Addendum for:

Minitrend V5 and Multitrend Plus V5 User manual 43-TV-25-07 Issue 10

Summary of points covered in this Addendum:

Circular chart

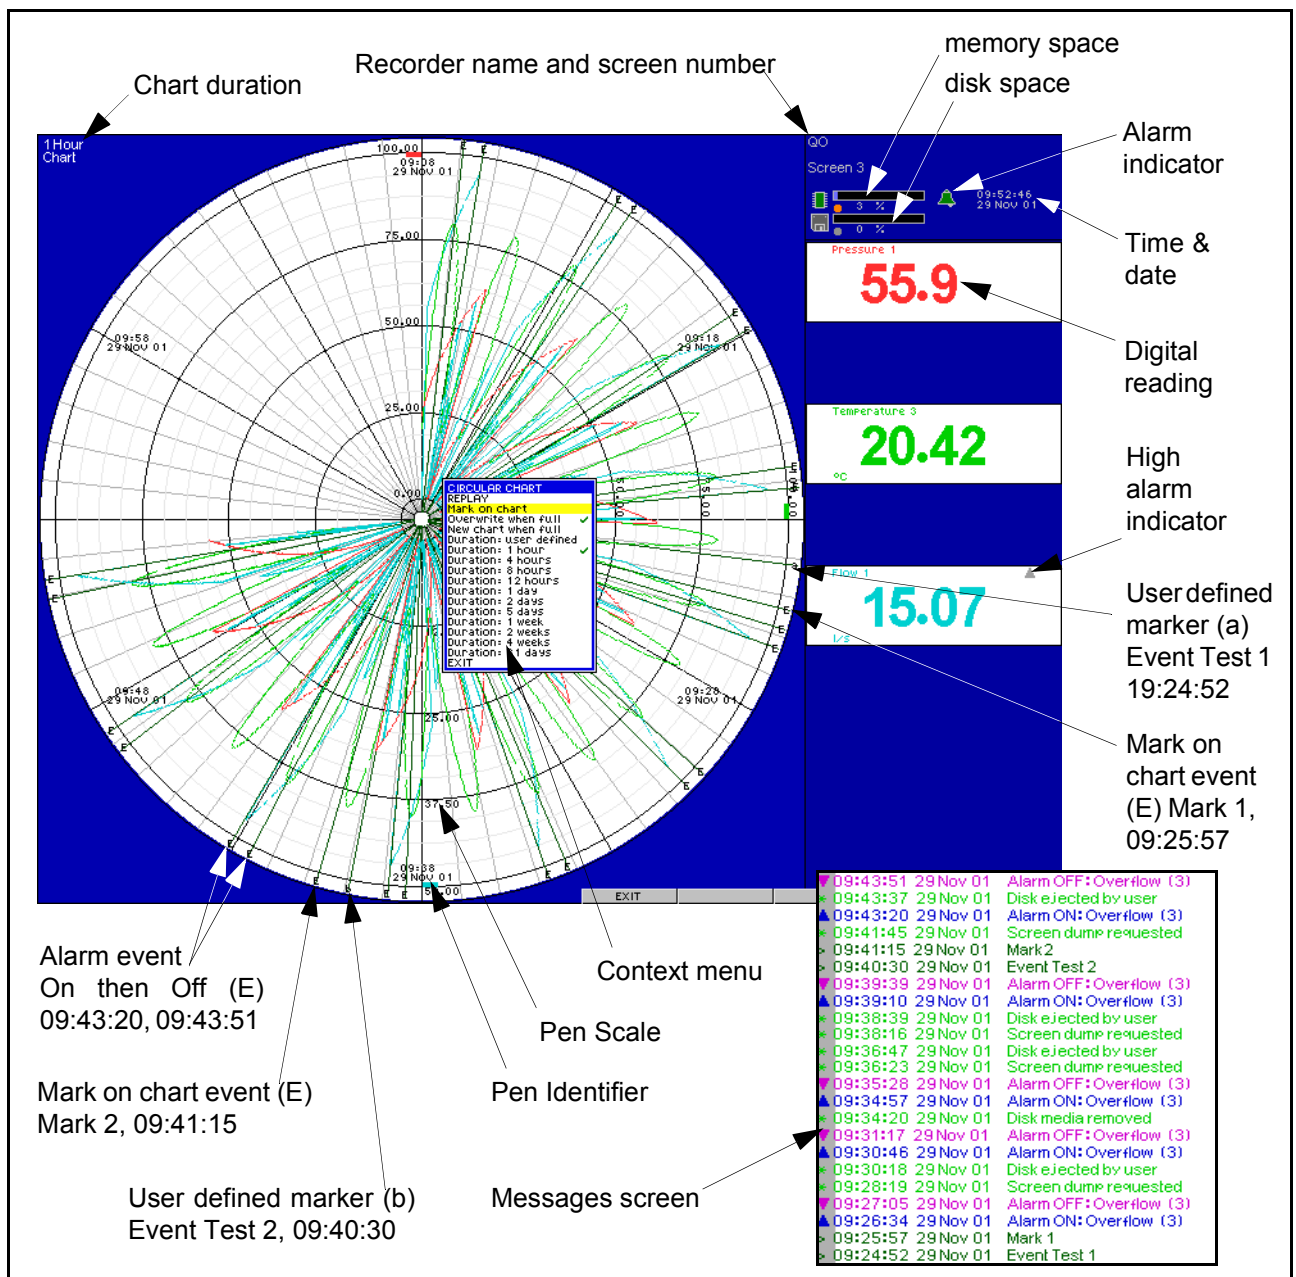
new section added:

One of the latest features unique to the *Multitrend Plus V5* is the circular chart. The circular chart starts at the top, at the 12 o'clock position, and moves round in a clockwise direction. All pens that have been enabled will display as a trend on the circular chart and as a digital reading. Full recorder status is displayed showing the screen and recorder names, time and date readings and memory, disk and alarm status indicators. Full replay facility is available to enable the user to scroll back through previous data.

Battery Isolation

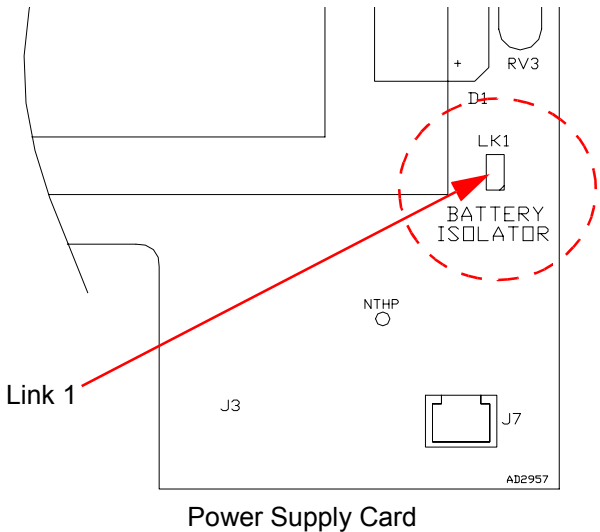
New section added:

To save the life of the battery during prolonged storage times it is recommended a link is disconnected on the Power Supply card.

Locate Link 1 (LK1) on the Power Supply card, do not completely remove the link as it will have to be reconnected when the recorder is ready for use. Simply pull the link up, turn it 90° and refit leaving only one pin connected. This will disconnect the link and ensure the link does not get lost.

FIGURE 1

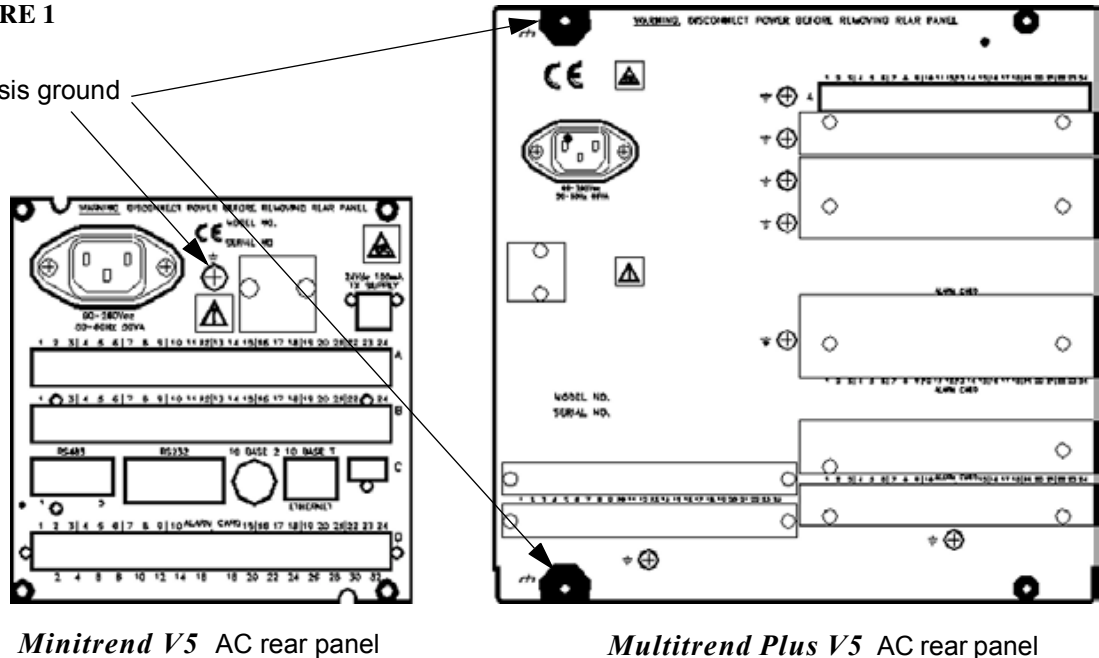
'Figure 1 on page 21' now shows chassis ground points.

Linear Input card (*Minitrend V5* only)

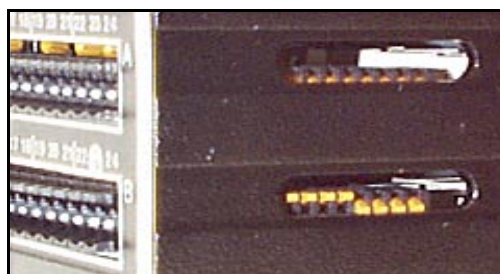
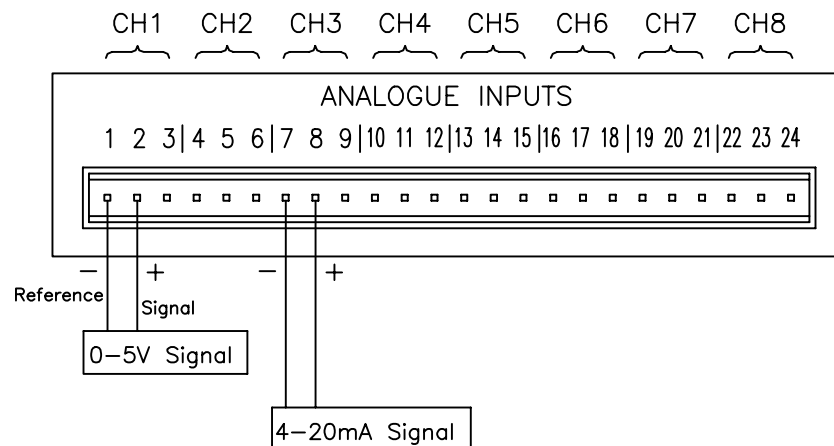
New section added

Set Current or Voltage switches

The ten ohm shunt resistors for mA input ranges are switched and the switches are located on the side of the recorder. Numbering from 1-8 corresponds to the pen of the same number.

The example below shows a 0-5 Volt device connected to channel 1 and 4-20mA device connected to channel 3.

Figure 1.

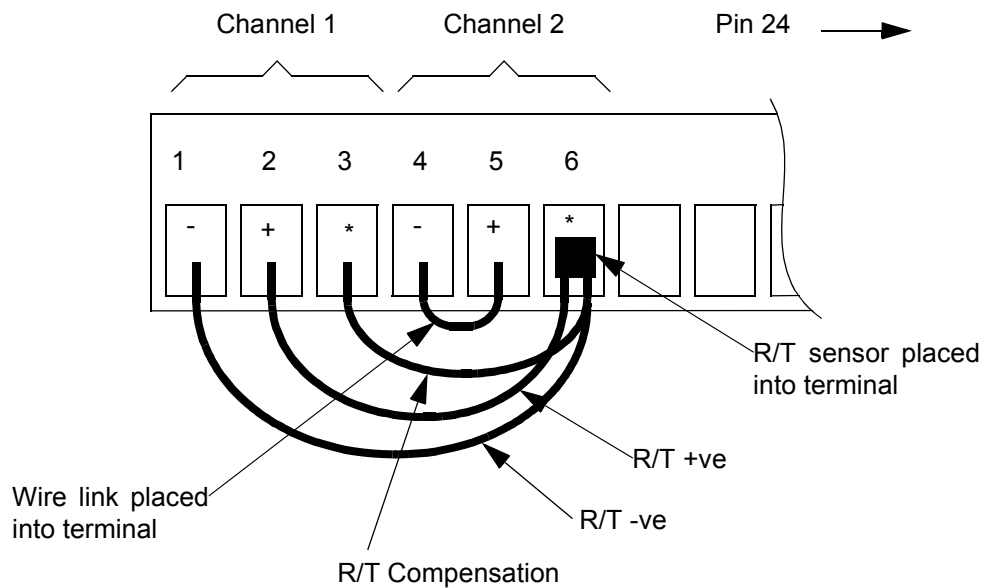
[Figure 1 on page 7](#) shows how to wire an R/T across the first channel to measure the temperature of the terminal. This must be done on the first channel of each Universal card fitted. For this calibration ensure channel 1 is enabled as a Resistance Thermometer and any other channel (2) for the Type K Thermocouple.

Square Root Extraction

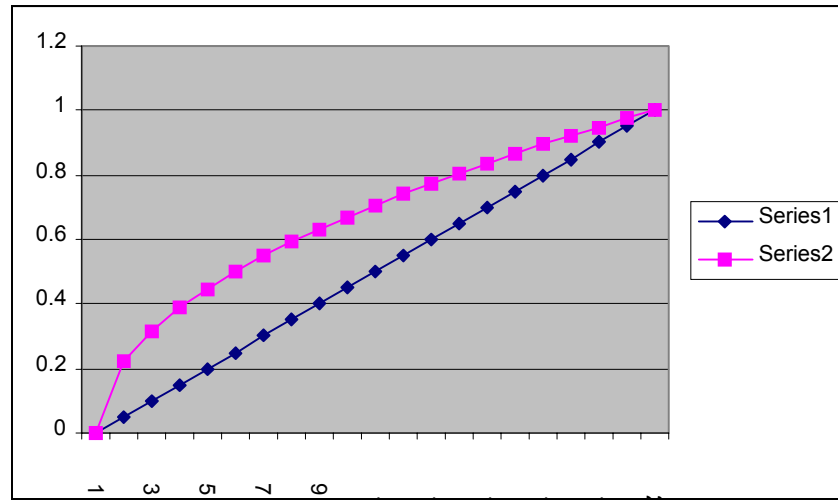
The Square root extraction in the analogue input is used to linearise certain sensors that have a non linear output - for example in the calculation of flow. So when you check the Square root extraction in the Analogue input section it carries out the following calculation.

It ratios the analogue input range that you set, to 0 to 1.

Temperature Calibration:

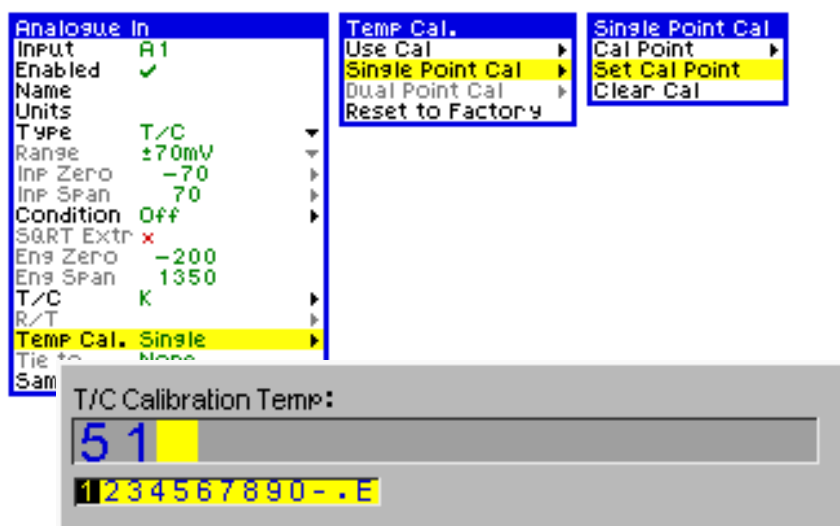
This section has been re-written:

Both thermocouples and resistance thermometers may require additional **Temperature Calibration** to eliminate system measurement errors. A single point calibration can be set up for each input using **Set Cal Point**.
